Re: *Joint Livingston Remediation Group (LRG) and BNSF Railway Company (BNSF) Work Plan Submittal – Revised Sub-Slab Depressurization and Expansion of Soil Vapor Extraction – Electric Shop*

**Subject: Revised Sub-Slab Depressurization and
Expansion Soil Vapor Extraction – Electric Shop
Burlington Northern Livingston Shop Complex – Livingston, Montana**

REVISED SUB-SLAB DEPRESSURIZATION AND EXPANSION OF SOIL VAPOR EXTRACTION – ELECTRIC SHOP

Job#: LRGM01 Task 5	FIGURE 1
Date: 1/15/2014

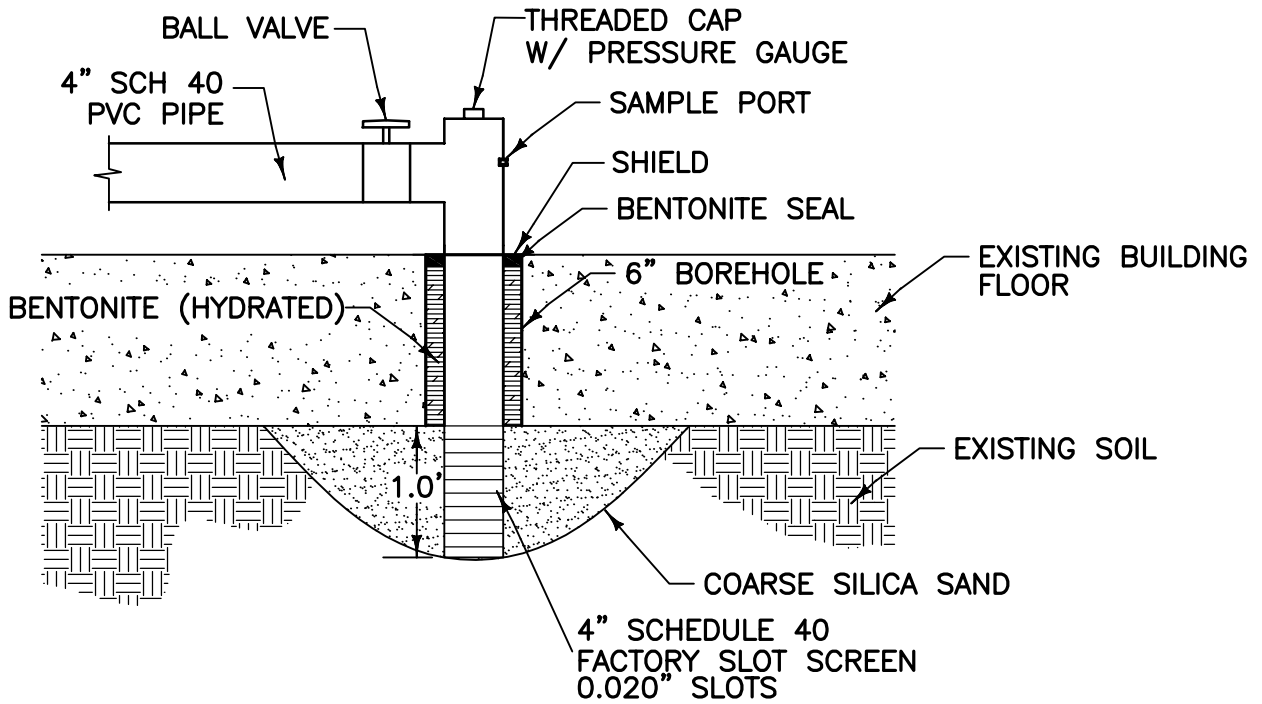
In addition to the DEQ revisions, per the telephone conference with BNSF, WET, and DEQ conducted on January 13, 2014, one additional sub-slab depressurization point will be added to the system in the vicinity of wells 89-3 and 90-2. This point has been added to Figure 1 of the revised work plan.
